**Report – Principle Technical Advisor
Aurora Electricity Distribution Revenue Review
Revised Proposal**

A report to the AER

Final Report

19 April 2012

Figure 1 Pole condemnations and capex

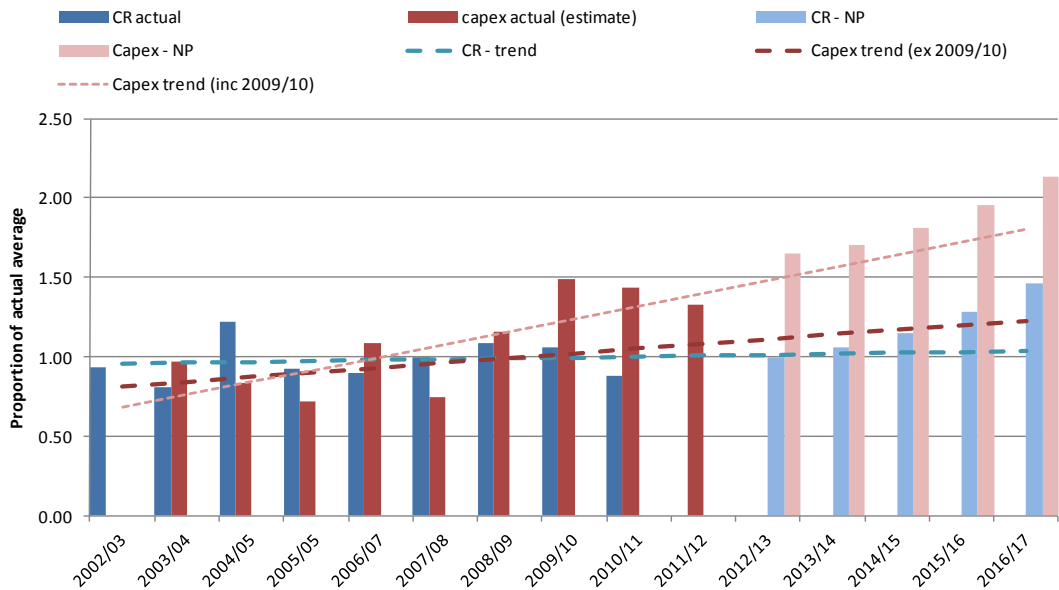
The figure shows the points noted above, namely the capex step up from the trend and condemnations increasing above the trend. This figure also shows that the large step increase in actual 2009/10 capex has a large impact on the capex trend. If this year is removed, the trend in capex is much lower.

In addition to the above, we also considered that the replacement lives suggested by the forecast condemnations in the next period were too low. We did not believe that replacement requirements would change to that degree, and the implied lives were not in line with what was being achieved by other DNSPs. We also did not consider that the type of pole used by Aurora was a sufficient reason for this forecast trend in condemnation rates and capex.

Figure 2 Historical SAIFI and effect of non-demand capex

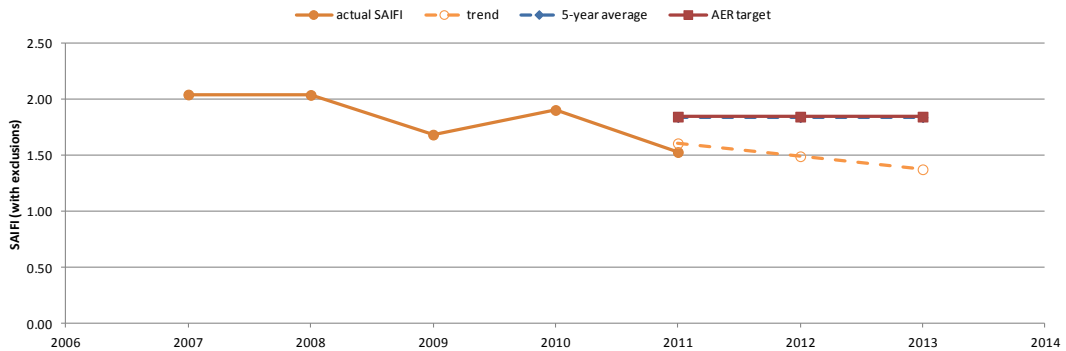
suggests around a 6% per annum improvement in SAIFI. The prediction based upon this trend is significantly lower than that from the simple 5-year average. Moreover, the prediction based upon the trend is also significantly lower than the AER SAIFI target, which makes some small adjustments from the 5-year average to account for the TRIP programs. This analysis suggests that other capital programs have probably had a significant impact in improving reliability over the current period.

Based upon the above, we are not convinced that Aurora requires a provision in its capex allowance associated with these local reliability programs. Consequently, we do not consider that the position in our original report needs to be changed.

Figure 3 Public light failure rates

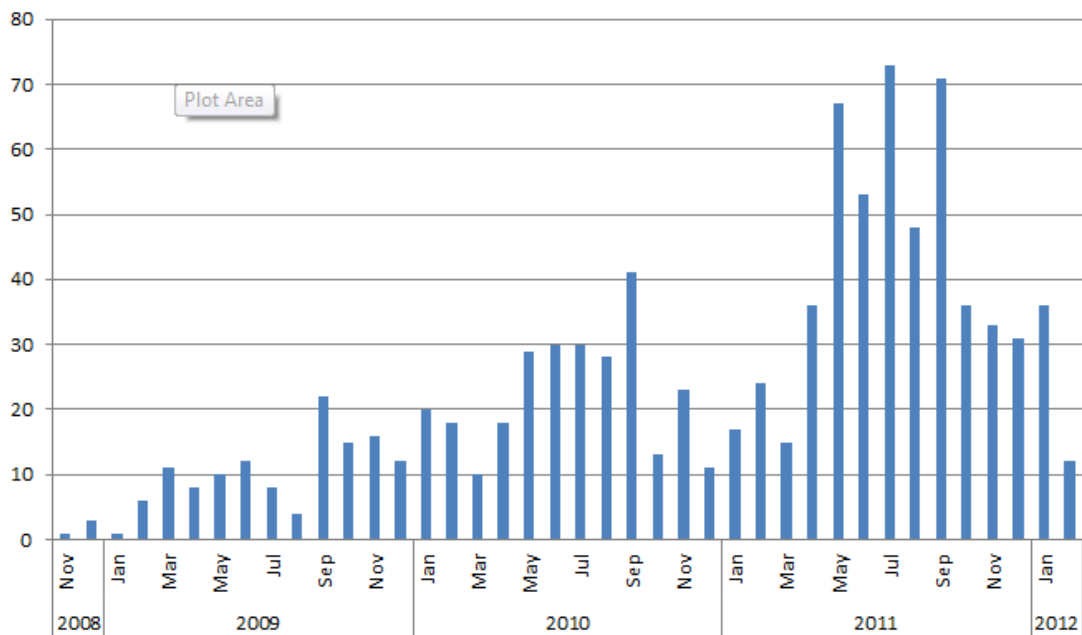
Nuttall Consulting has reviewed the lamp failure rates and confirms that a significant increase in lamp failures is evident from the information provided by Aurora. The following figure highlights both a longer term increase in failure rates and a very large increase in 2011.
